MARICOPA COUNTY
Department of Transportation

MEMORANDUM

Case 13-01 A

Date: January 15, 2013
To: MAG Specifications and Details Committee
From: Robert Herz, MCDOT Representative
Subject: Correction to Detail 501-5

| DETAIL NO. 501-5 | STANDARD DETAIL ENGLISH | HEADWALL DROP INLET | REVISED 01-01-1998 | DETAIL NO. 501-5 |

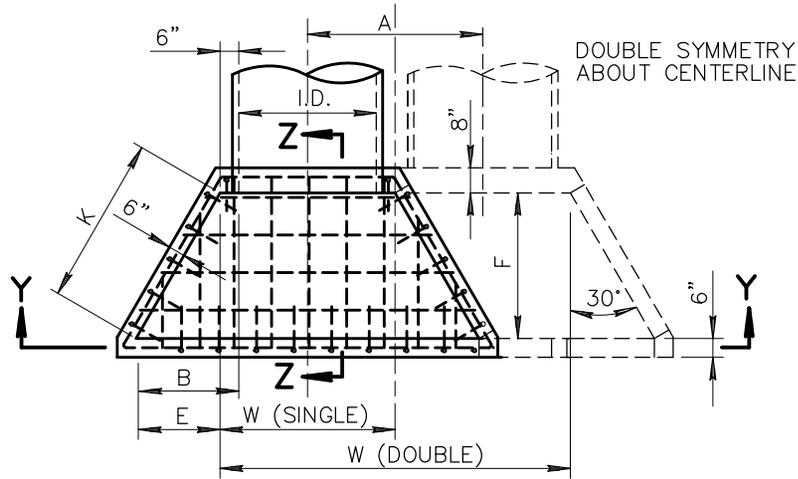
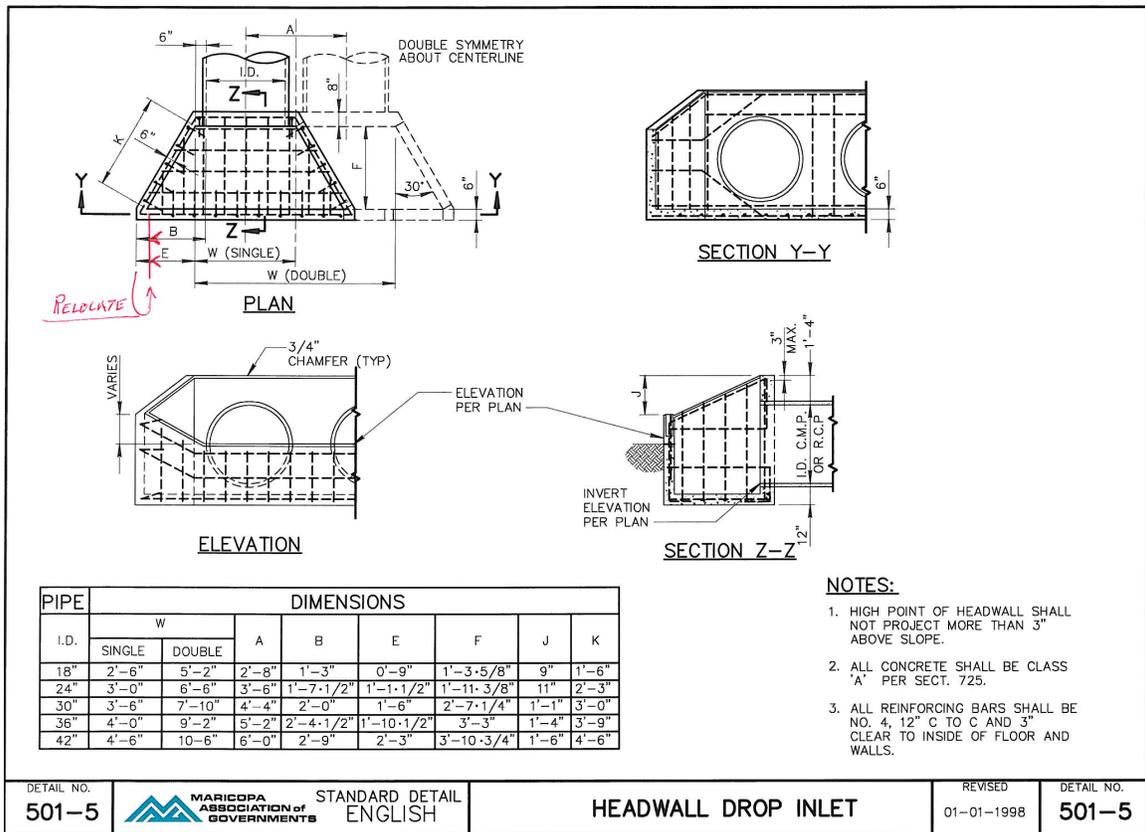
PURPOSE: Correct depicted distance B and E shown on PLAN view of Detail 501-5.

Variable distance B and E shown on the PLAN view are presently shown to the outside edge of the inlet basin wall, they should be shown to the inside edge of the inlet basin wall.
 (Distances E and F are the legs of a right triangle with hypotenuse K.)

DETAIL NO.
391-1

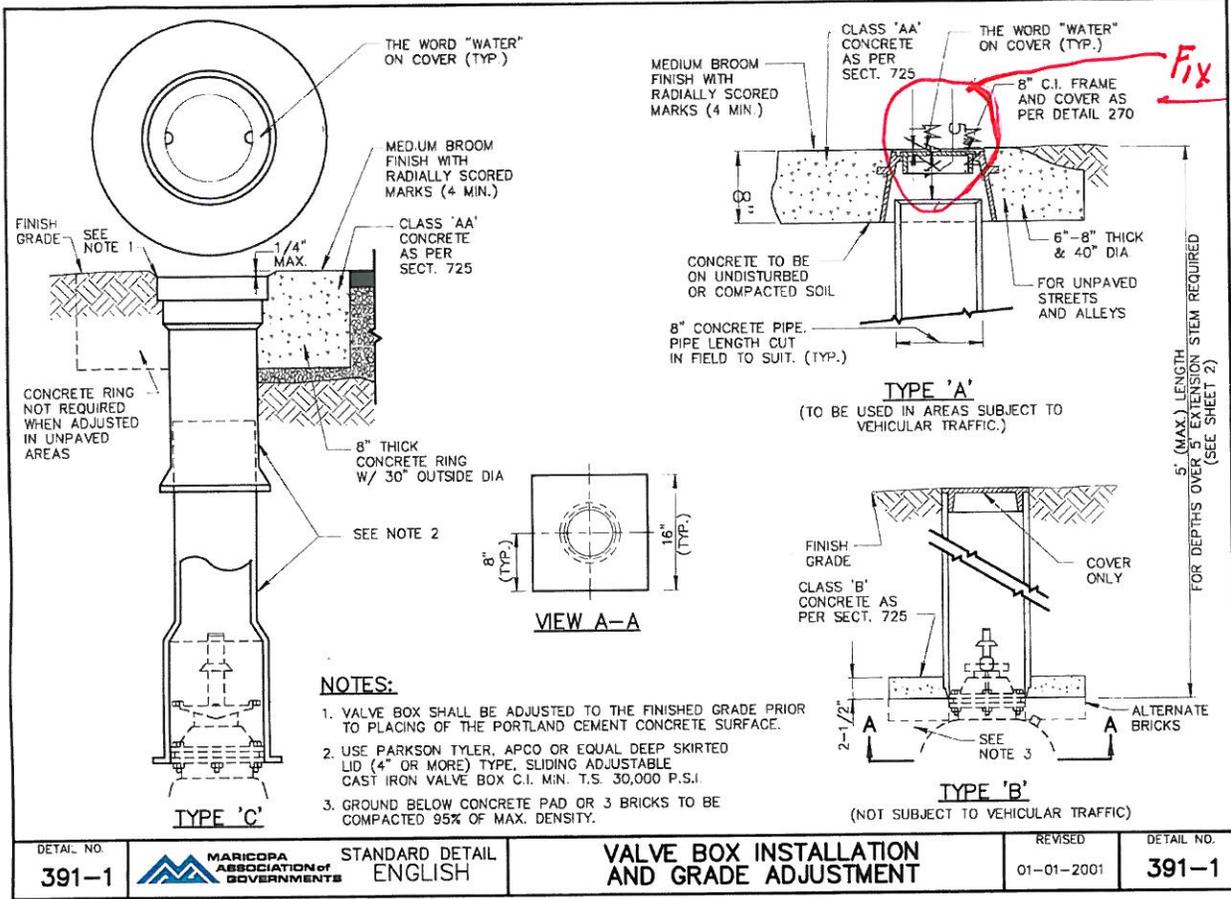
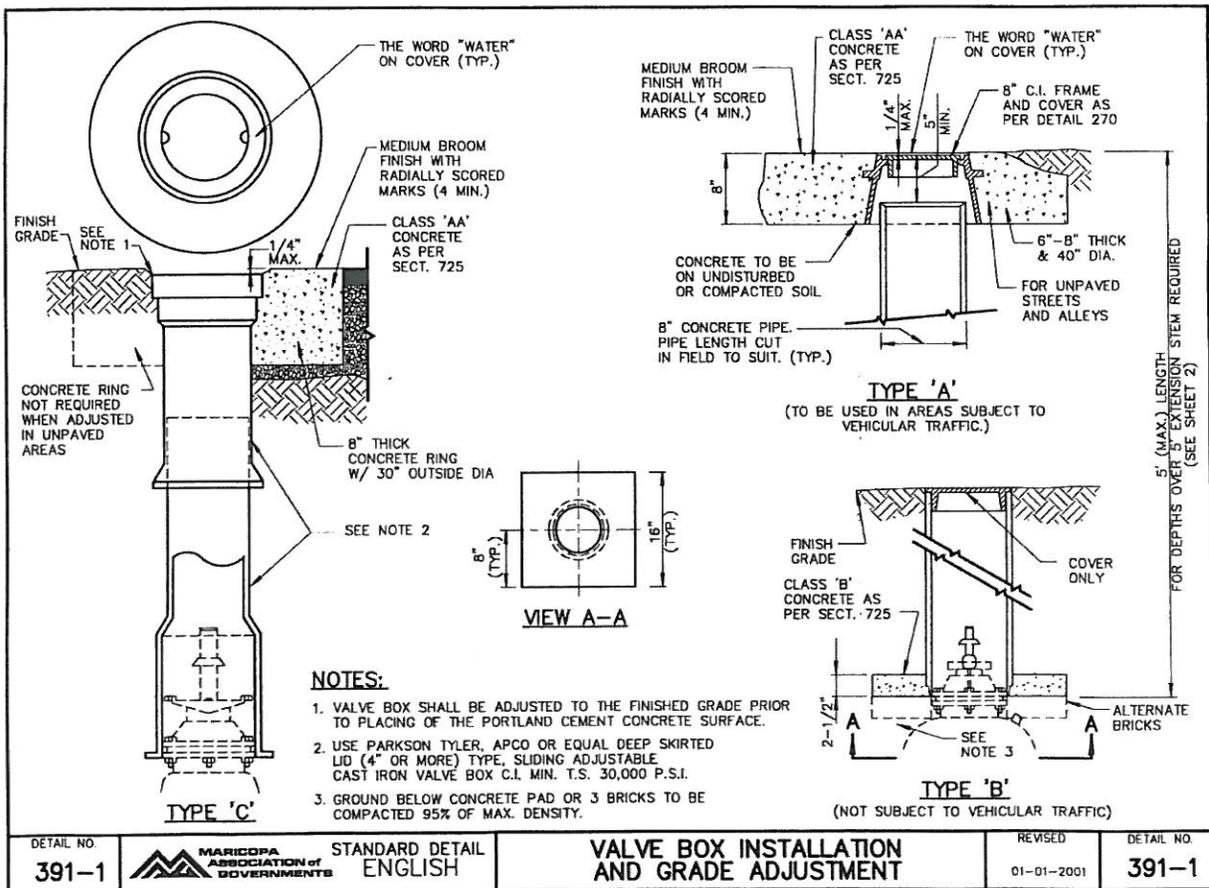
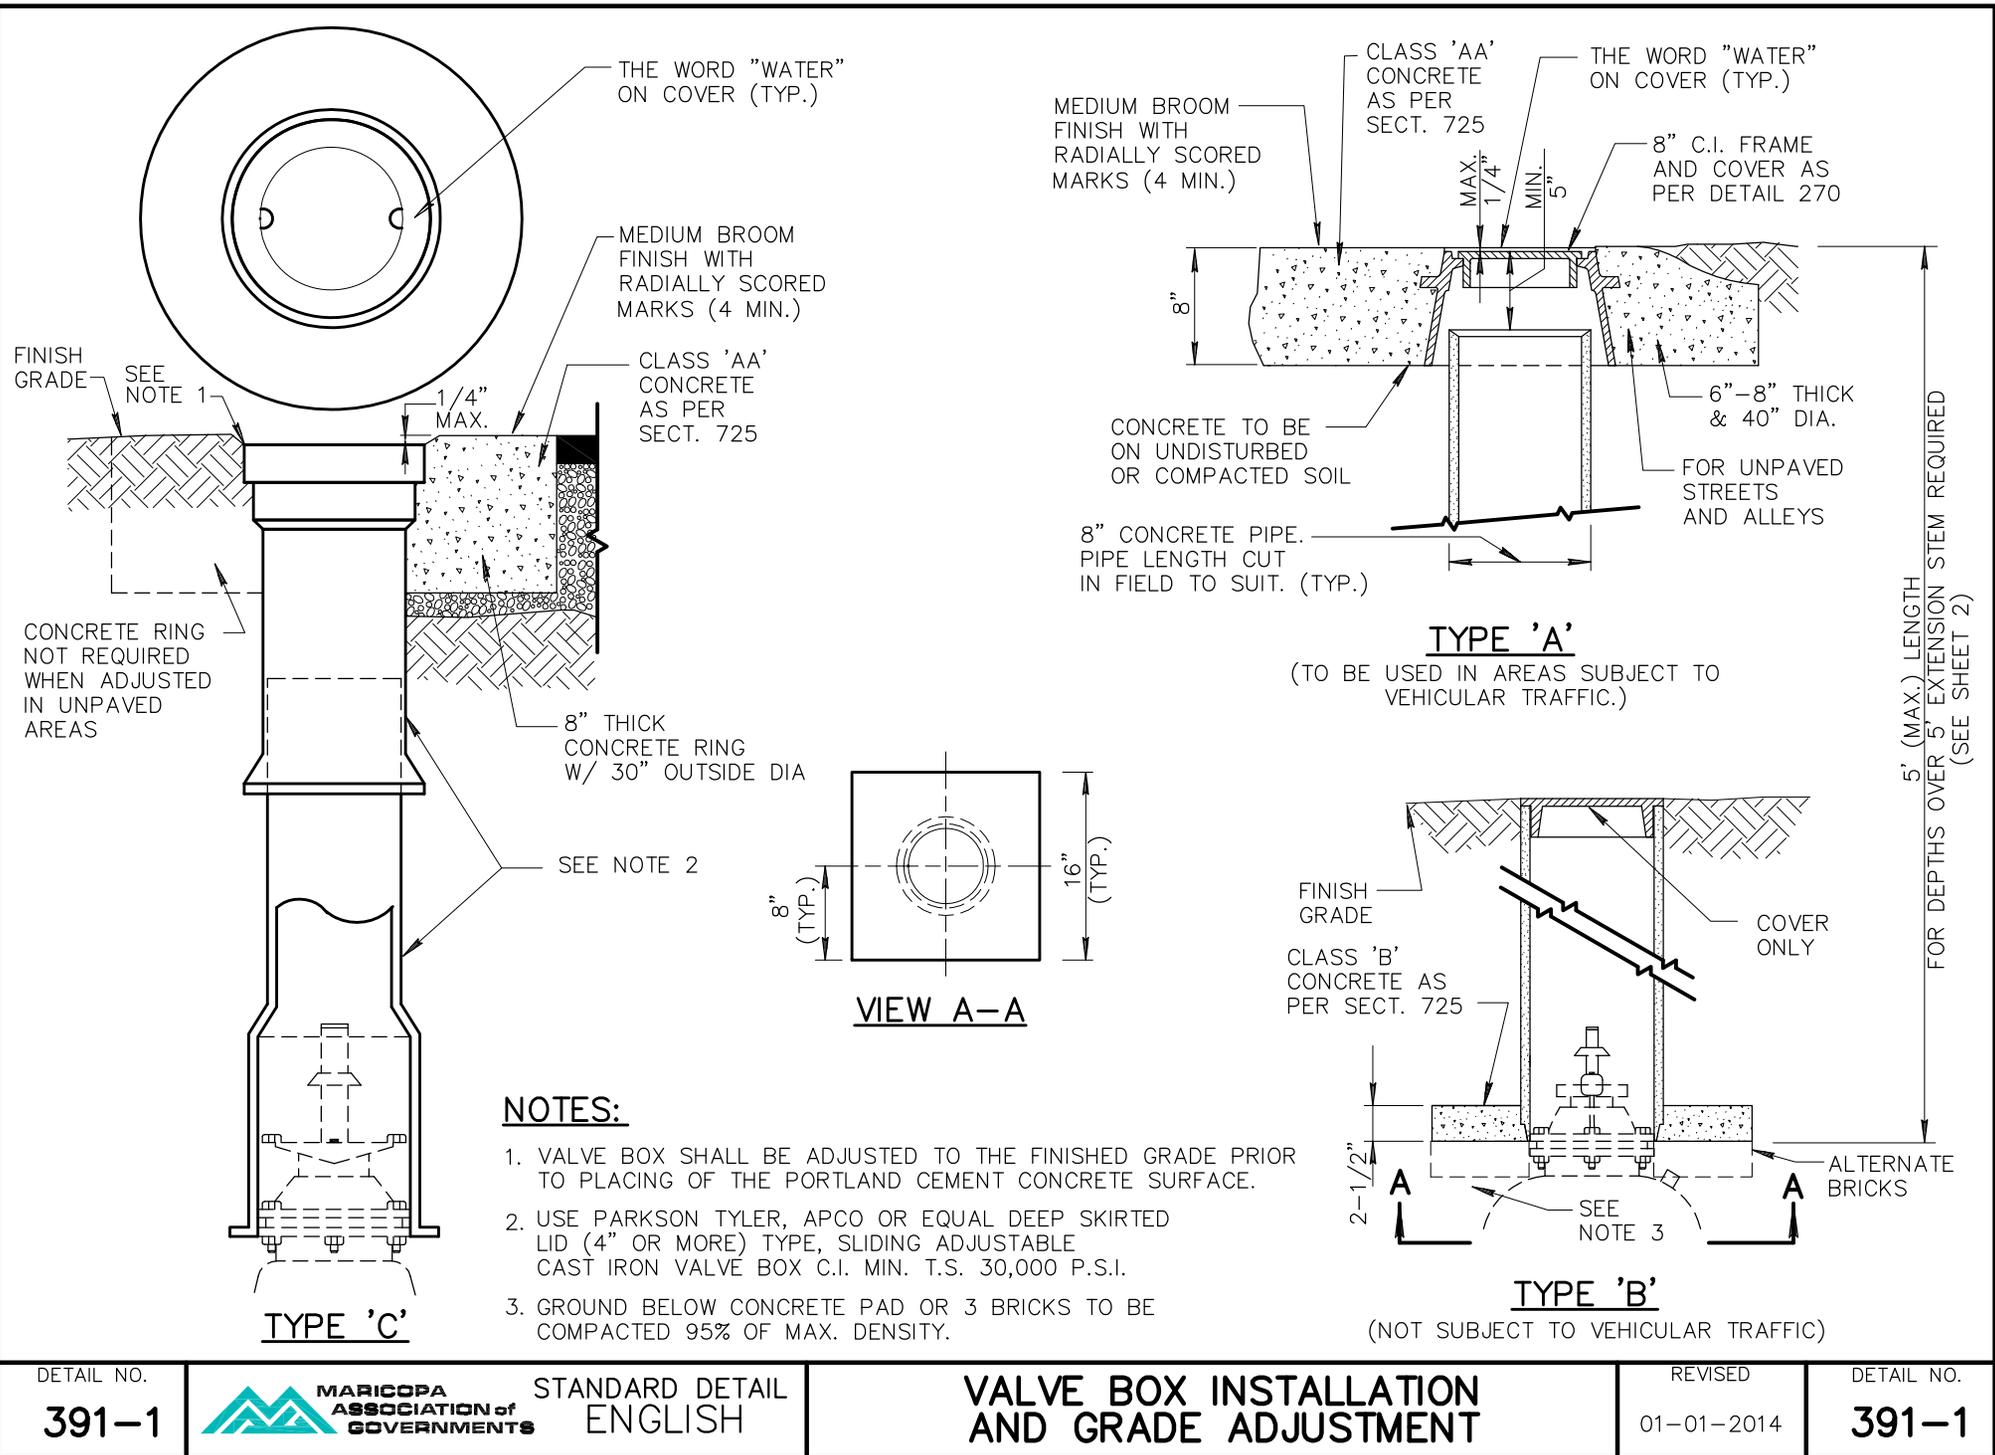
DETAIL IN 2013

DETAIL IN 2011
